“Good” and “Bad” Modifications to OPTIMOD-FM Model 8000A

by Robert Orban
Chief Engineer
Orban Associates, Inc.
Revised and edited 2/8/2000

8000A FREQUENCY RESPONSE AS HF LIMITER HEADROOM IS CHANGED

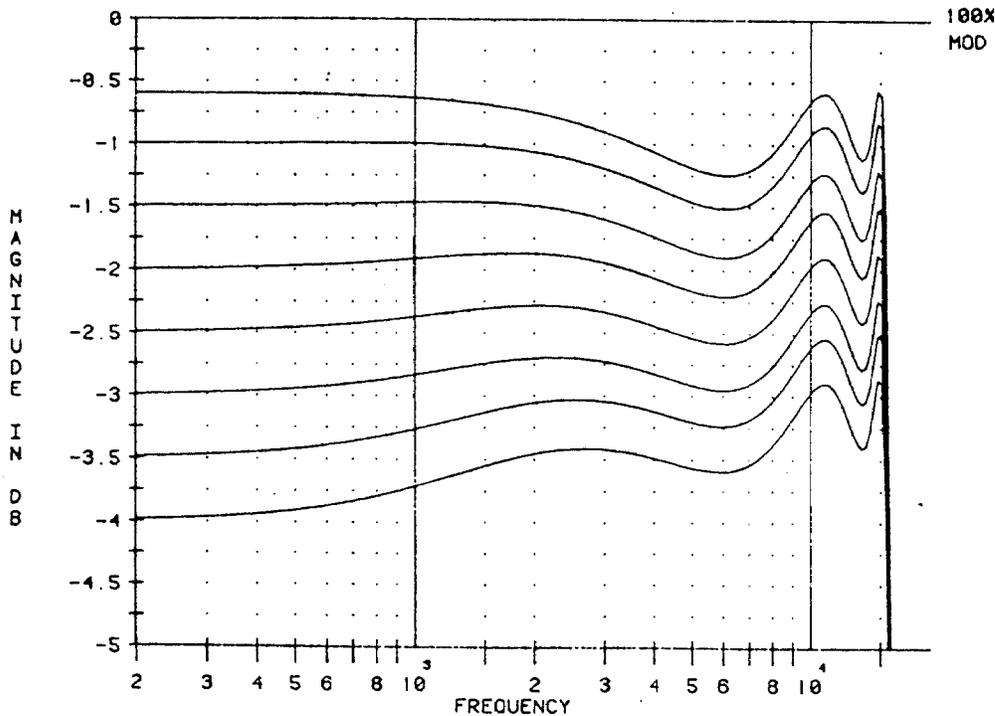
The adjustment in the 8000A is a carefully considered "commercial" compromise between loudness and brightness. However, stations wishing to give up loudness to achieve more brightness can change the value of R239, R240. These resistors pass the unpreemphasized component of the signal through to IC209B, IC210B. Adjusting their value therefore adjusts the preemphasis headroom without disturbing critical source and load impedances in the circuitry.

These changes will disturb the preemphasis curve slightly. The graph included with this monograph gives the expected de-emphasized frequency response of the 8000A system for the various resistor values tabulated assuming that P205, P206 were optimally adjusted for the original value of 11.8K. It can be seen that in the worst case (4.0dB headroom), the preemphasis rises by about 1.1 dB at 15kHz.

The appropriate values of R239, R240 for various amounts of headroom are as follows:

Headroom	R239, R240
1.0dB	12.4K
1.5dB	13.0K
2.0dB	14.0K
2.5dB	14.7K
3.0dB	15.4K
3.5dB	16.2K
4.0dB	17.4K

In many cases, this will not cause unsatisfactory sound quality or difficulties in meeting FCC Proof of Performance requirements. However, if you wish to restore the preemphasis to a maximally flat condition, this can be done by sweeping the system and readjusting P205, P206 for equiripple response (similar to the “0.6 dB” curve in the graph). With the rear-panel TEST jacks in NORM, observe the output of the rear panel TEST jacks through a *precision* 75 μ s deemphasis network. Note that the networks in most modulation monitors are designed for aural monitoring only, and are insufficiently accurate for this adjustment! (A precision network can be built by connecting a 7500 ohm 1% resistor from the network’s input to its output, and then shunting the output with a 0.01 mfd 1% capacitor. No lower impedance than 1 megohm should load the network.)
